RE: Cooperative Educational Services (CES)
10601 Research Rd. SE
Grading and Drainage Plan
Engineer's Stamp Date: 10/30/19
Hydrology File: M21D021

Re: Cooperative Educational Services (CES)
10601 Research Road, S.E.
Grading and Drainage Plan Stamp Date 04/15/19
Hydrology File: M21D01

NEW OFFICE BUILDING
COOPERATIVE EDUCATIONAL SERVICES (CES)
10601 RESEARCH RD. SE, ALBUQUERQUE, NM 87123

D1 STANDARD CURB OPENING
N.T.S.

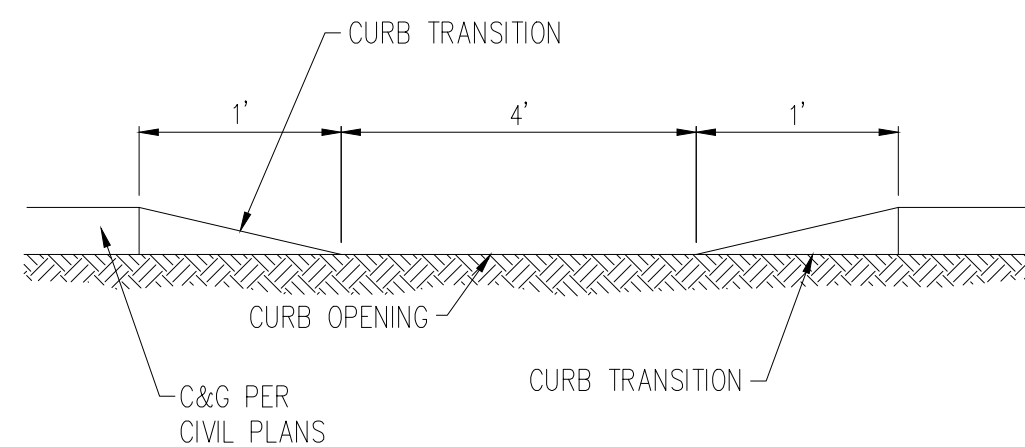
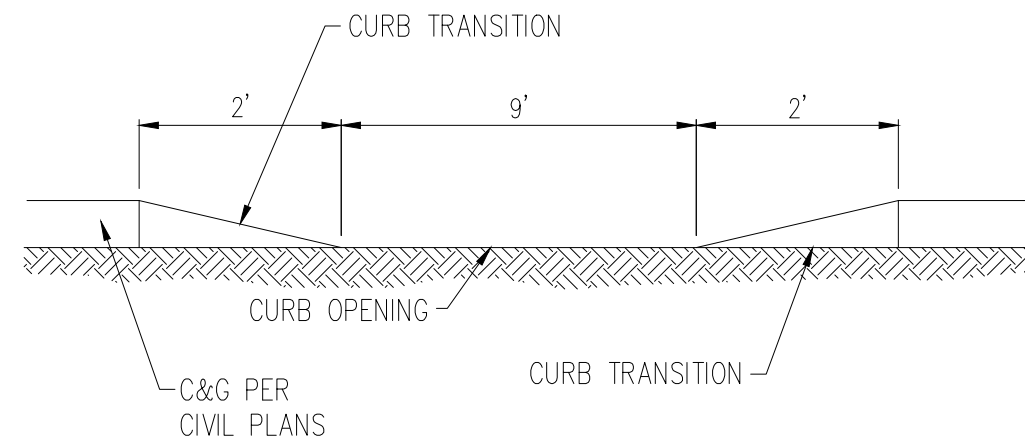
14. Sheet C302. Please use the broad crest weir equation in the DPM for the curb cuts. If you use a "C" value of 2.7, then the proposed 4 ft curb cuts can be reduced to a 2 ft curb cut and the 9 ft curb cut will be reduced to a 5 ft curb cut. **Although we realize that we can optimize the size of the curb cut by using a "C" value of 2.7, we have decided to utilize a more conservative approach and use a "C" value of 3.1 and a wider curb cut due to geometry and a conservative approach.**
